## Design Review Subcommittee (DRSC)

Meeting Date: August 11, 2021

**SUBJECT:** **Cultural Heritage Permit 21-054, Casa Rosa Duplex**, a request to consider the construction of a two-story duplex building on a vacant lot located within the Architectural Overlay District.

1ST FLOOR PLAN  
LANDSCAPE

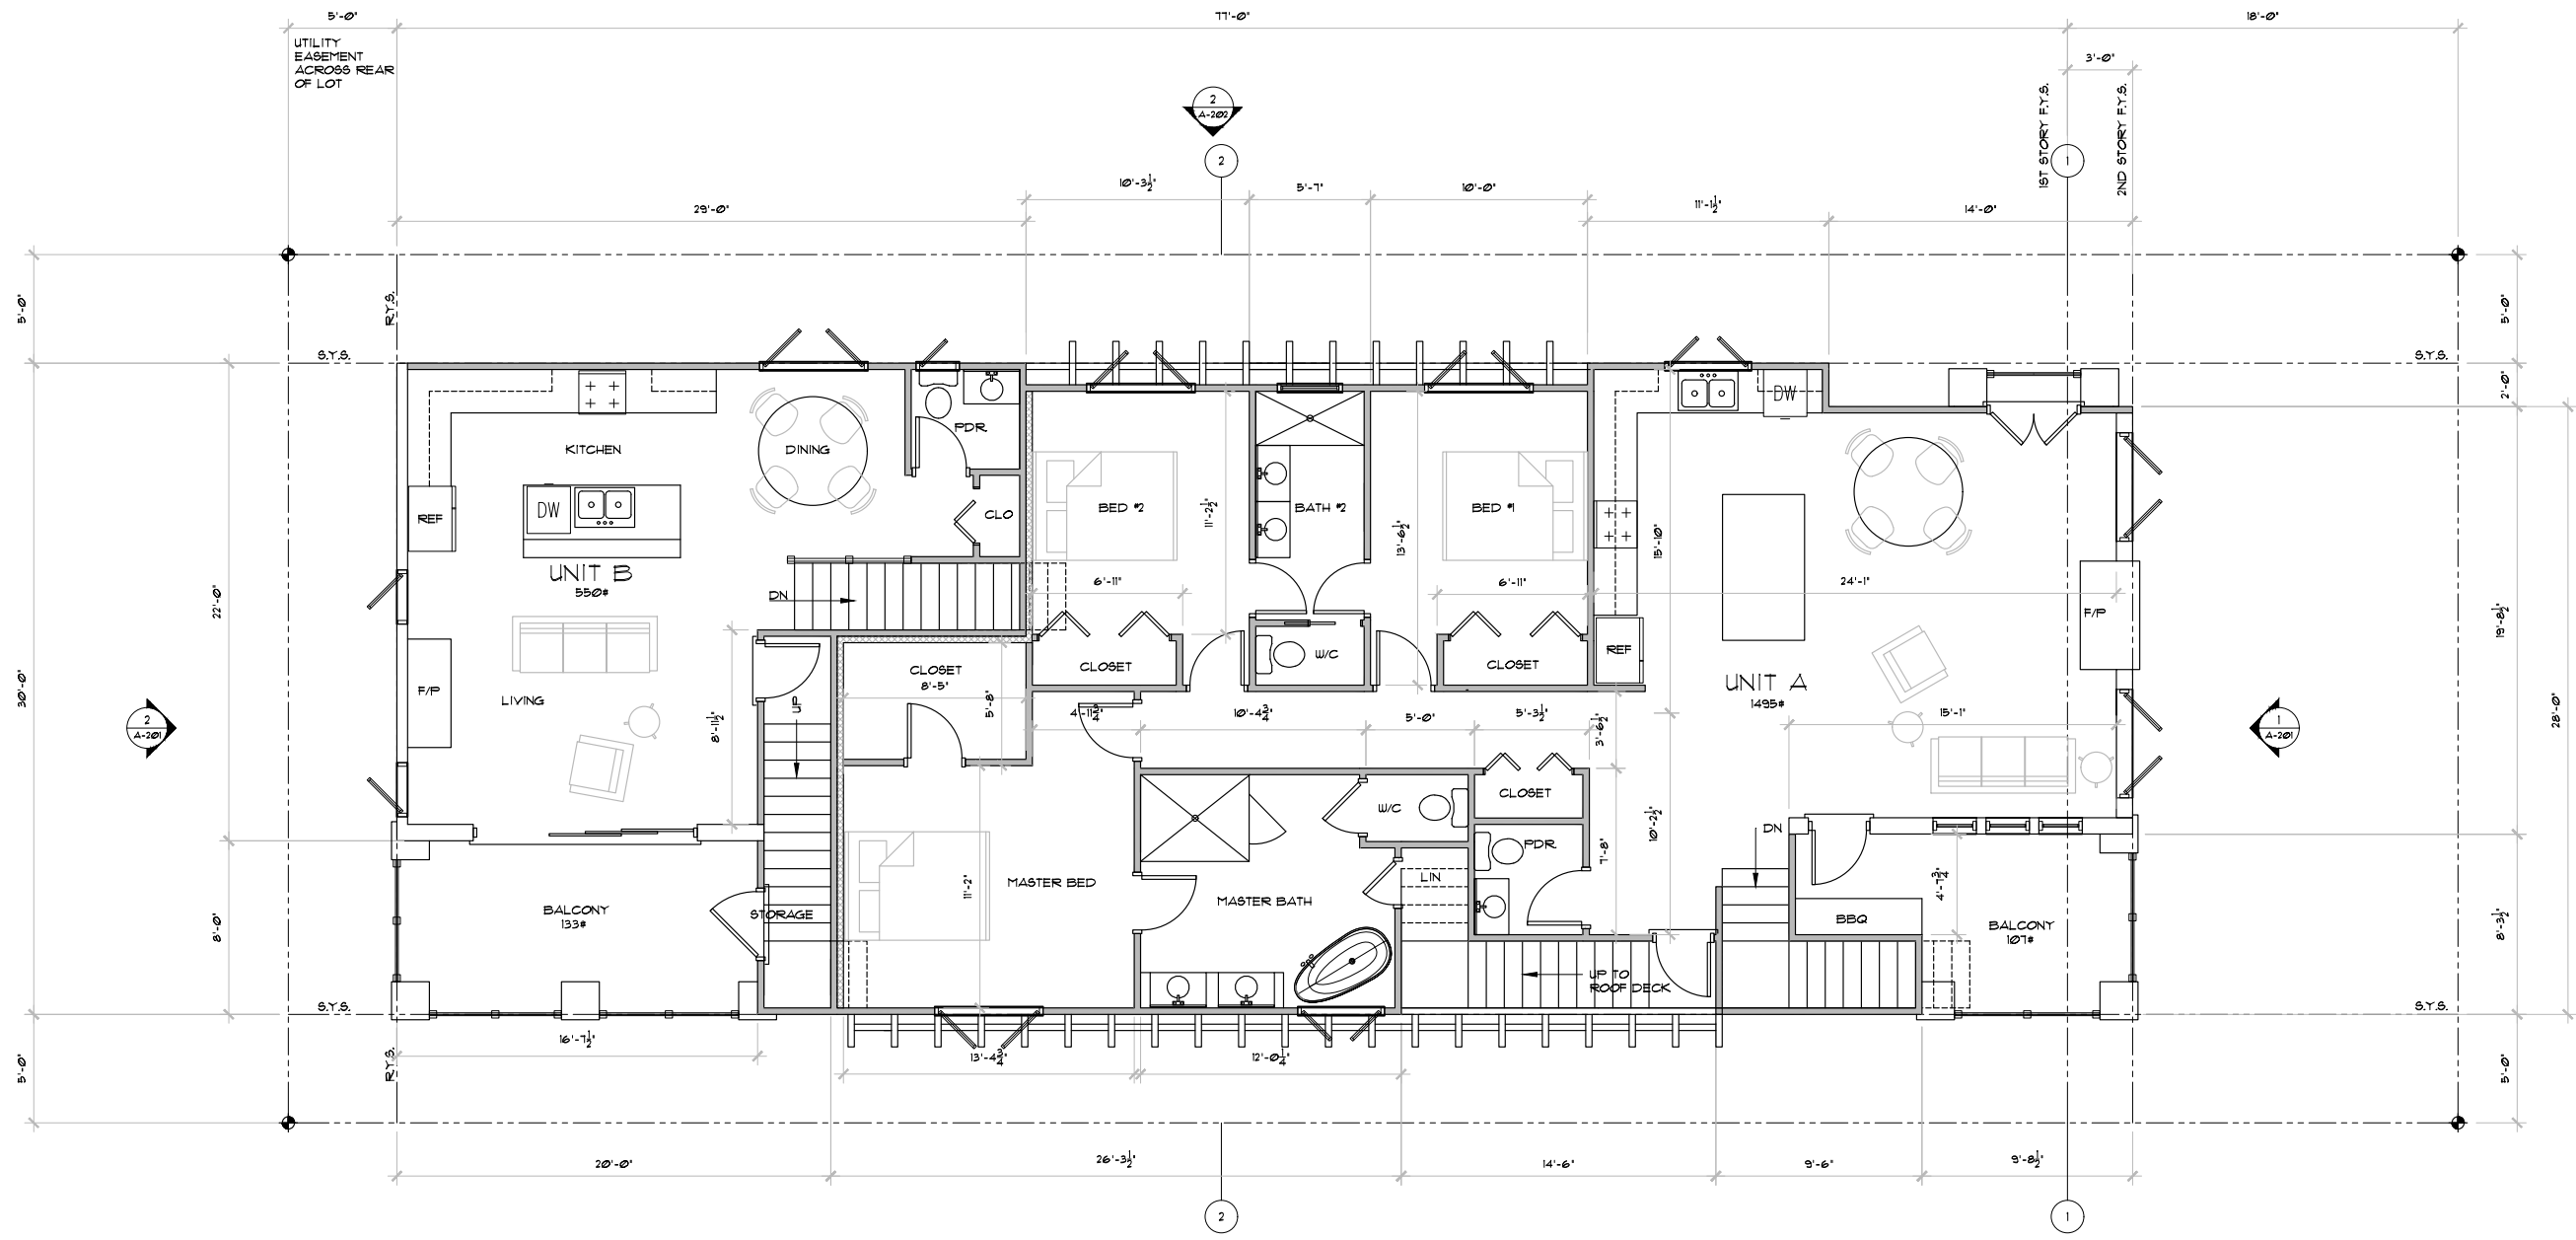
- Recommendation: Emphasize the entry to both units.
  - LU – 1.05.i. - Minimize the total area of driveway paving in relation to landscaping.
    - Recommendation: Reduce the amount of concrete on the driveway by providing turf block pavers.

The City's Landscape Consultant reviewed the preliminary landscape plan and determined that more detail on the plan is required prior to obtaining preliminary approval. More detail on the proposed plant palette is requested in order to identify plant species and their compliance with the City's drought-tolerant and native standards. Additionally, vertical vines along the property parameter to soften wall surfaces are recommended. Prior to scheduling the project for a Planning Commission hearing, the applicant will need to address comments from the City's Landscape Consultant.

FRONT ELEVATION  
 $\frac{1}{8}''=1'$

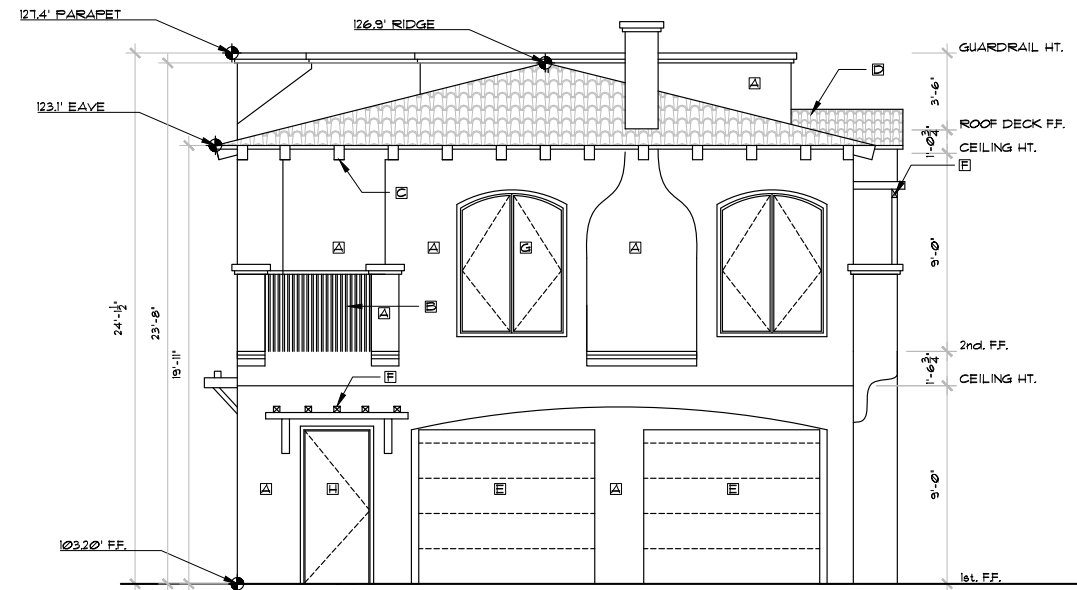
- Recommendation: Remove wood trellis eyebrows.
    - Recommendation: Reduce the size of windows on the front elevation.
  - DG II.C.3.c - The relation between the height of a column and its mass or thickness should be visually consistent with the weight of the overhead structure it supports.

4. Remove wood trellis eyebrows.
5. Reduce the size of windows on the front elevation.
6. Reduce the bulkiness of the balcony on the east elevation by removing stucco columns.

A-201

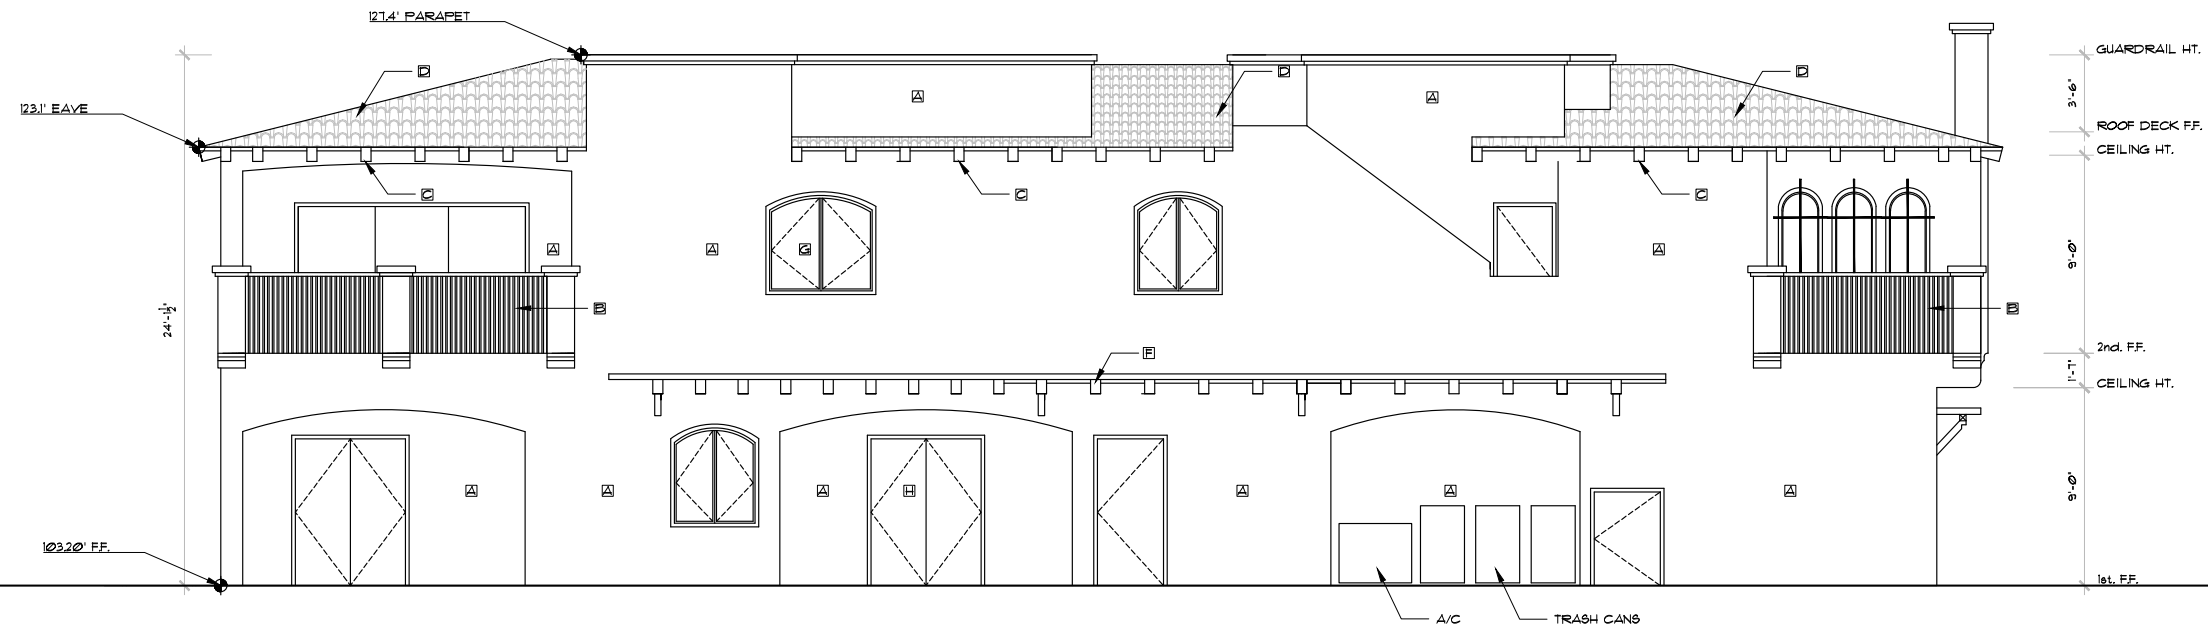
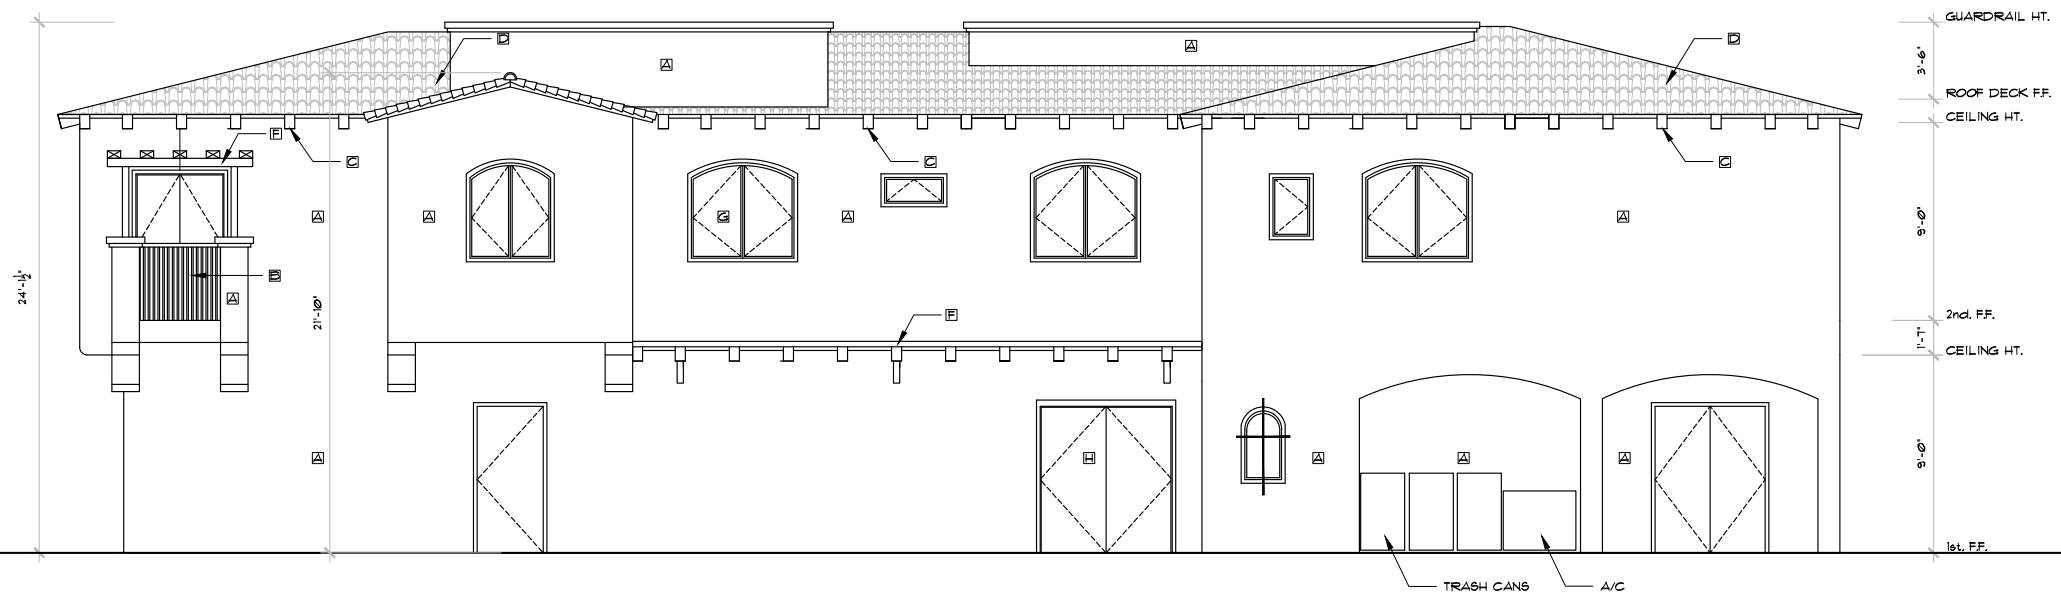
- Recommendation: Reduce the bulkiness of the balcony on the east elevation by removing stucco columns.
